January 20, 2020

Re: **Final Report: Water and Sewer System Peer Review for Proposed 147-Unit Apartment Building at 19-35 River Street by SLV River Street, LLC**

**FIGURE 2**  
**TOWN OF WINCHESTER, MASSACHUSETTS**  
**19-35 RIVER STREET PEER REVIEW**  
**RECOMMENDED SEWER SYSTEM REHABILITATIONS**

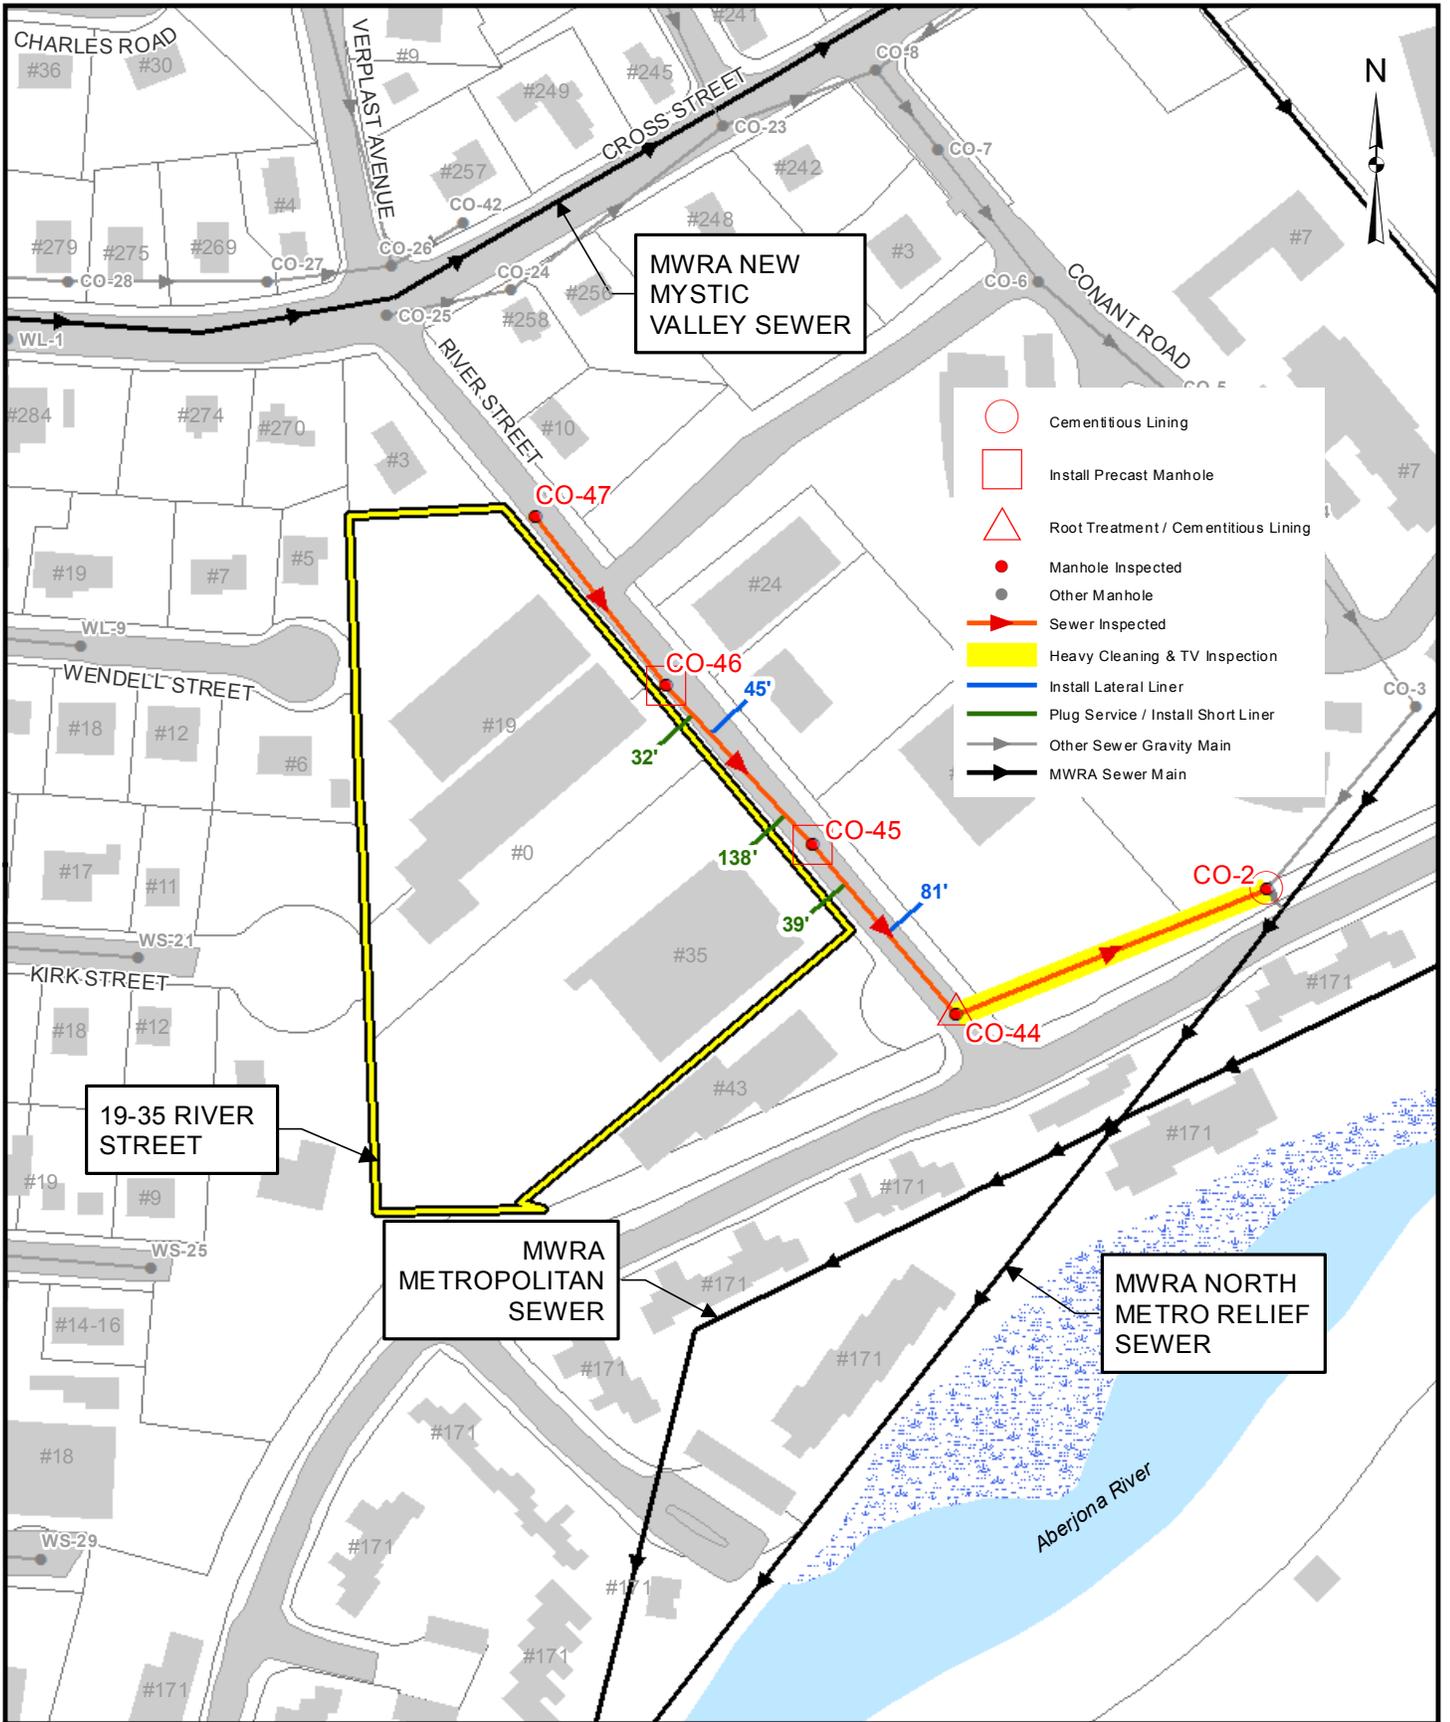
Our review of the pipe inspection video identified three (3) active services in the direction of 19-35 River Street, which will be disconnected once the existing buildings are demolished. We recommend abandoning these services at the mainline by plugging them with grout and installing a cured-in-place short liner over the service connection. The inspection also identified two (2) active services with infiltration staining at the break-in pipe connection. We recommend installing lateral liners at these locations.

TV inspection of CO-44 to CO-2 identified moderate debris along the invert of the pipe from station 1+50 to station 2+80. Complete TV inspection of this pipe segment was obtained; however, we recommend performing additional cleaning in this pipe segment.

Our review of the manhole inspection data identified two (2) manholes with active infiltration and four (4) manholes with root intrusion. Weston & Sampson recommends performing root treatment at CO-44 and CO-47 and cementitious lining at CO-2, CO-44, and CO-47. Manholes CO-45 and CO-46 are recommended to be replaced with precast manholes as discussed above.

Weston & Sampson recommends the following sewer rehabilitations:

- Install two (2) lateral liners
- Abandon existing sewer services at 19-35 River Street. Plug service with grout and install cured-in-place short liner; three (3) services, 12 linear feet of short liners
- Perform manhole chemical root treatment at CO-44 and CO-47
- Perform grouting and cementitious lining of manholes at CO-2, CO-44, and CO-47; 23.7 vertical feet
- Install new precast manholes at CO-45 and CO-46 for building service connection and gas/oil separation connection; 12.1 vertical feet
- Perform heavy cleaning and television inspection, CO-44 to CO-2, 290 linear feet

The estimated cost of these sewer rehabilitations is \$63,888. The proposed sanitary sewer rehabilitations are indicated on the map included as Figure 2.

- Install new precast manholes for all of the proposed building sewer main connections (CO-45 and CO-46)
- Weston & Sampson revised our recommendations for sewer rehabilitations to only include rehabilitations within the flow path of the development. Recommended sewer manhole rehabilitations at CO-47 were removed since this manhole is upstream of the development. We recommend the applicant (SLV River Street, LLC) pay for all rehabilitations to the sanitary sewer system within the flow path of the development (CO-46 to CO-2), in addition to the town's sewer demand fee (\$352,800). The recommended rehabilitations within the flow path are as follows:

- Install two (2) lateral liners
  - Abandon existing sewer services at 19-35 River Street. Plug service with grout and install cured-in-place short liner; three (3) services, 12 linear feet of short liners

- Perform manhole chemical root treatment at CO-44
  - Perform grouting and cementitious lining of manholes at CO-2 and CO-44; 17.0 vertical feet
  - Install new precast manholes at CO-45 and CO-46 for building service connection and gas/oil separation connection; 12.1 vertical feet

- Perform heavy cleaning and television inspection, CO-44 to CO-2, 290 linear feet

The estimated cost of these sewer rehabilitations is \$61,465.
